Re: St. Lucie Unit 1
Docket No. 50-335
Order (EA-03-009) Relaxation Request 2
Examination Coverage of Reactor Pressure
Vessel Head Penetration Nozzles – Supplement 3

**St. Lucie Unit 1
Relaxation Request Numbers 1 and 2 From
US NRC Order EA-03-009
Response to Request for Additional Information**

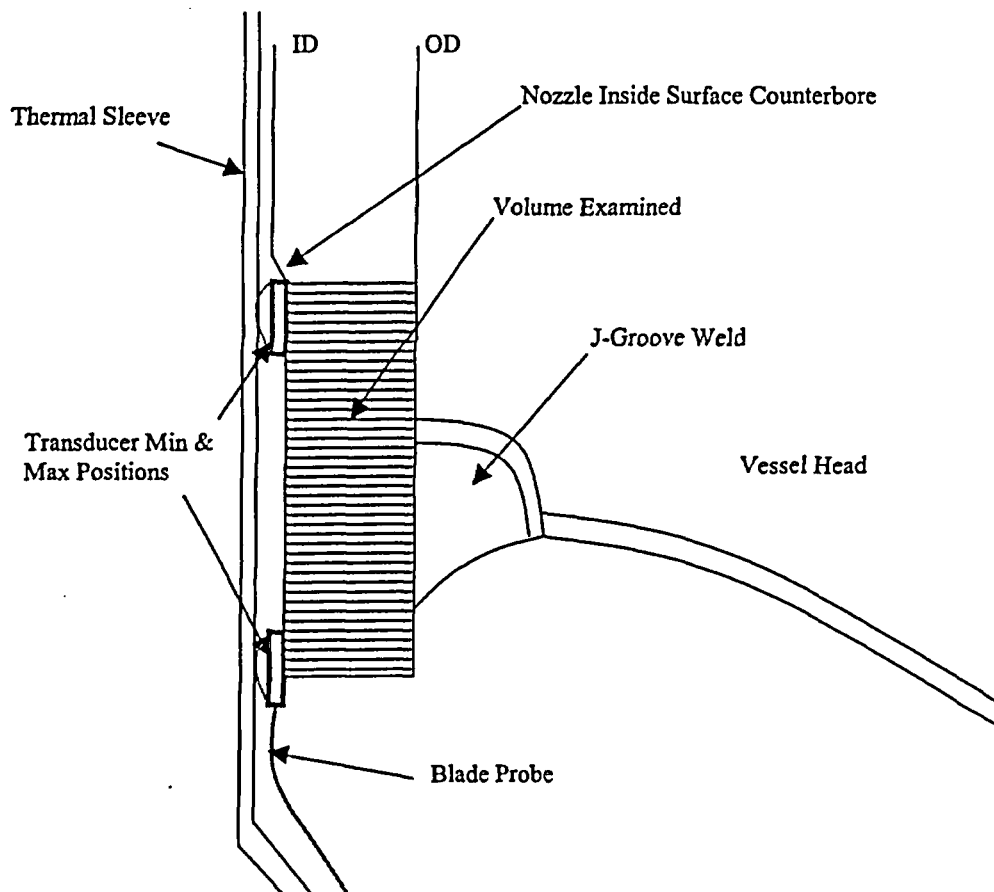
With respect to the 17 penetrations where ultrasonic testing (UT) coverage was less than 2.0 inches above the weld on the uphill side, were there any instances where that same arc of unexamined area extended to the downhill side of the weld? If so, what were the hoop stress levels in the unexamined areas?

FPL Response to NRC Question 4:

The minimum distance above the weld on the uphill side listed in the table represents a minimum horizontal plane measured from the uphill side of the weld root. This arc is centered around the uphill side of the nozzle. The coverage area beyond the uphill arc is greater than 2 inches above the weld for the 17 penetrations.
